DEVELOPMENT REVIEW BOARD SUPPLEMENTAL SUBMITTAL

PROJECT NO. PR-2018-001280
Application No. SI-2018-00049

SUBMITTAL DESCRIPTION: Updated Site Plan for Building Permit to remove refuse enclosures and replace
with one compactor enclosure and modifications to ramadas in amenities areas.

MARKANA APARTMENTS - II
SAN PEDRO AND ALAMEDA
Albuquerque, New Mexico

SITE PLAN FOR BUILDING PERMIT

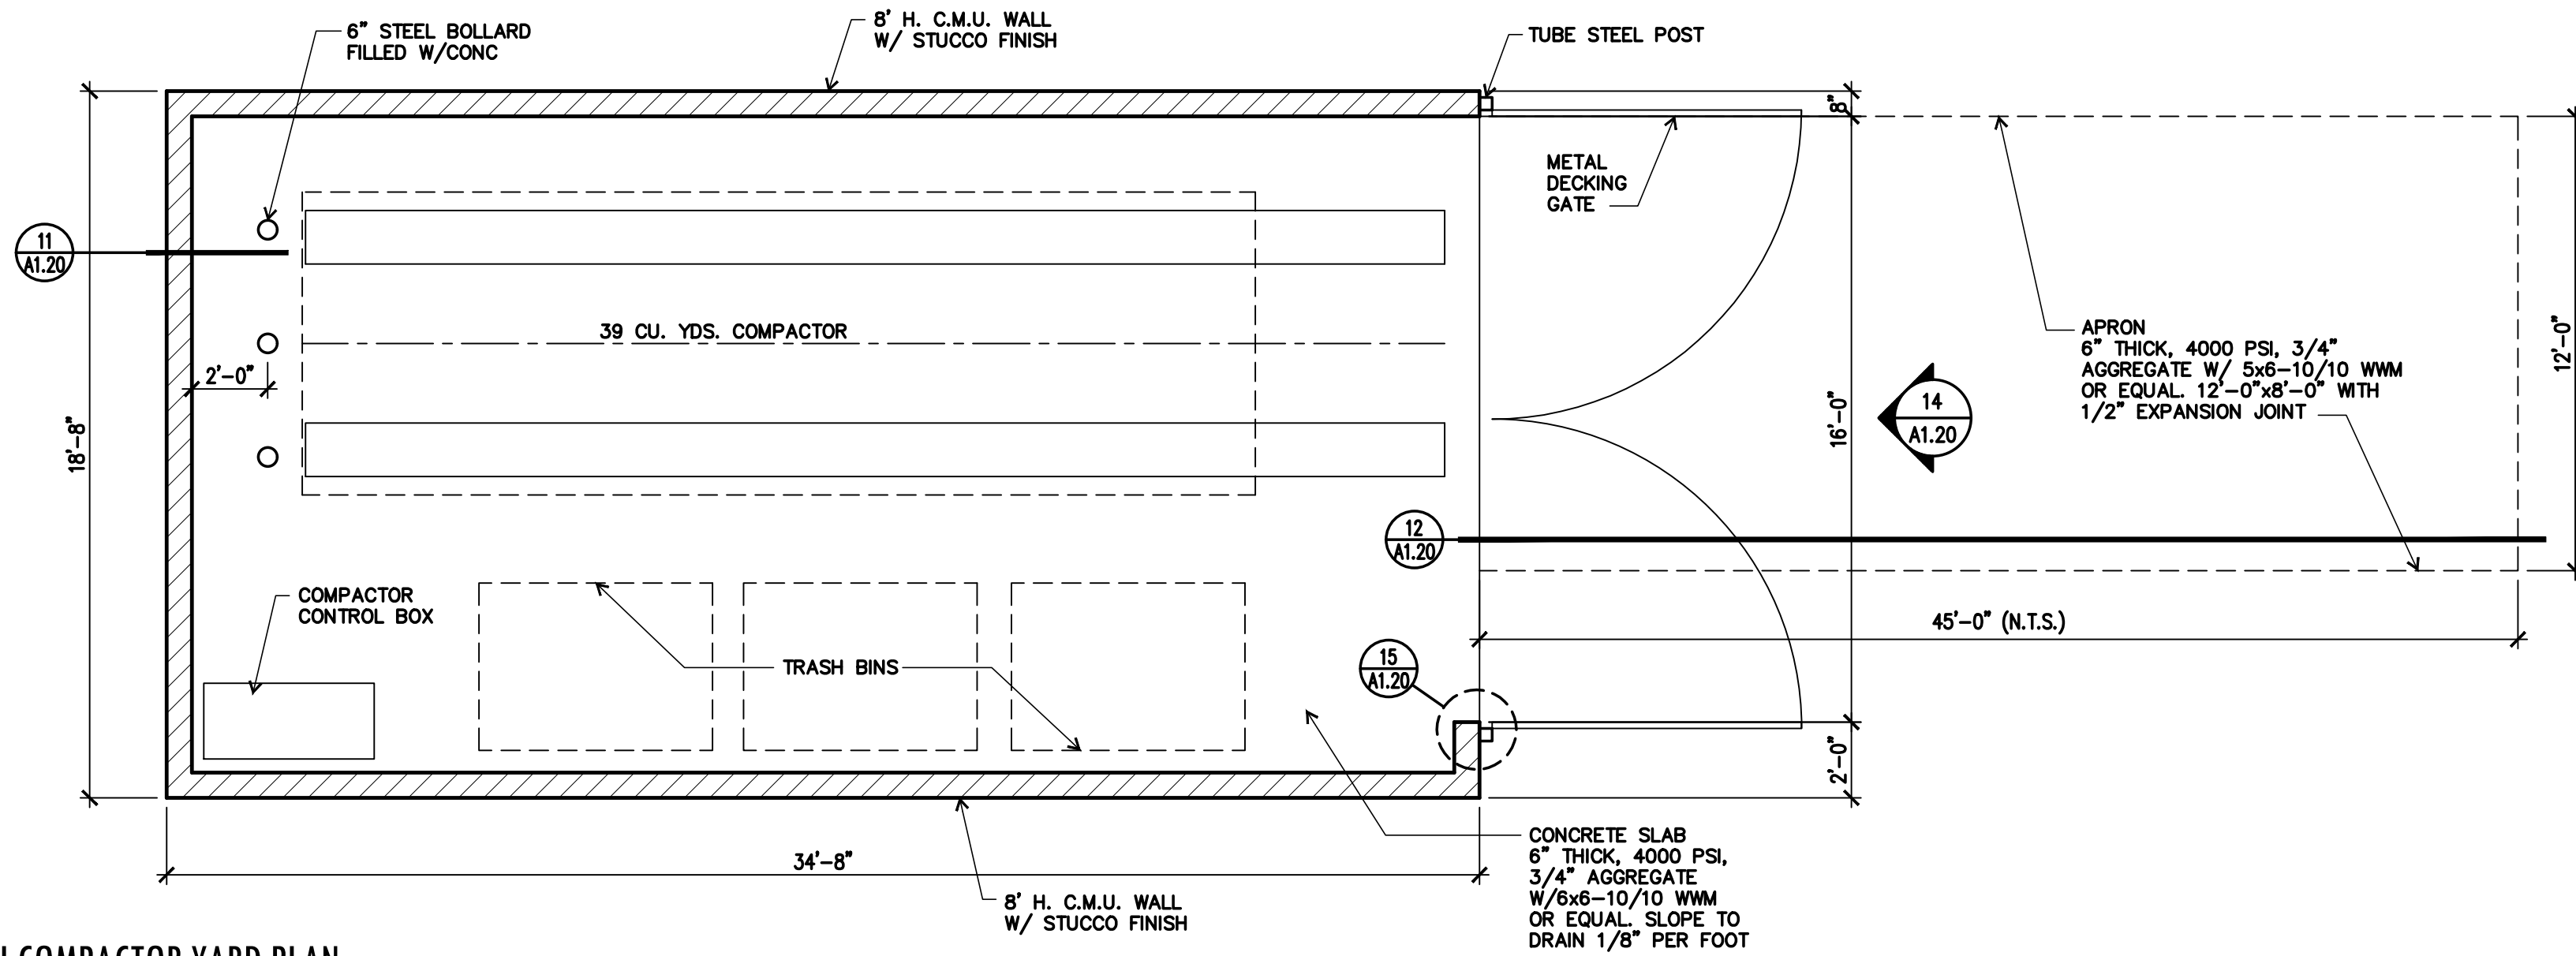
- 39' CU. YDS. TRASH COMPACTOR ENCLOSURE SURROUNDED BY 8' CMU WALL PAINTED TO MATCH BUILDINGS. SEE DETAIL 13/A1.20.
- 8' H. CMU WALL PAINTED TO MATCH BUILDINGS. SEE DETAIL 07/A1.20.
